Sundry ID: 2785996

POKER LAKE UNIT 22 DTD 185H

SUNDRY LANGUAGE

XTO Permian Operating, LLC. respectfully requests approval to make the following changes to the approved APD. Changes to include FTP, LTP, BHL, Casing sizes, Cement, Proposed total Depth, and formation (Pool).

WELL LOCATION AND ACREAGE DEDICATION PLAT

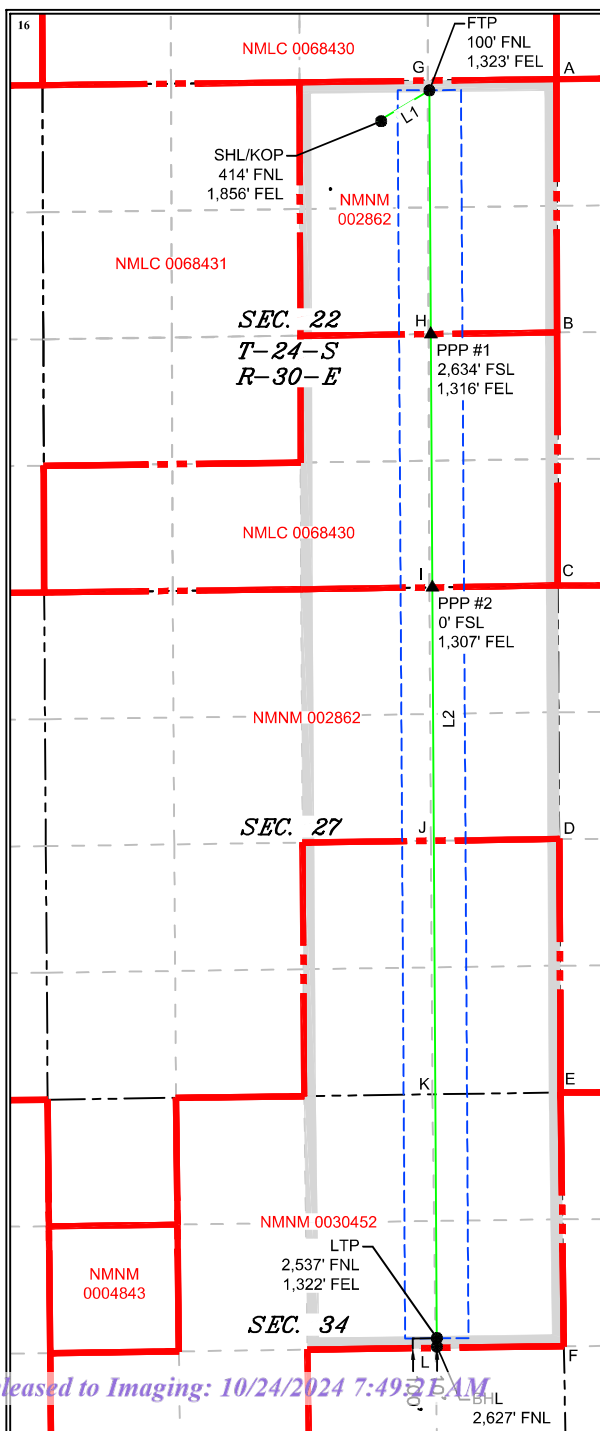
FTP: 100' FSL & 1750' FEL OF SECTION 15-T24S-R30E 100' FNL & 1323' FEL OF SECTION 22-T24S-R30E
LTP: 328' FNL & 1750' FEL OF SECTION 3-T24S-R30E 2537' FNL & 1322' FEL OF SECTION 34-T24S-R30E
BHL: 198' FNL & 1750' FEL OF SECTION 3-T24S-R30E 2627' FNL & 1322' FEL OF SECTION 34-T24S-R30E
Continued on page 3 additional information
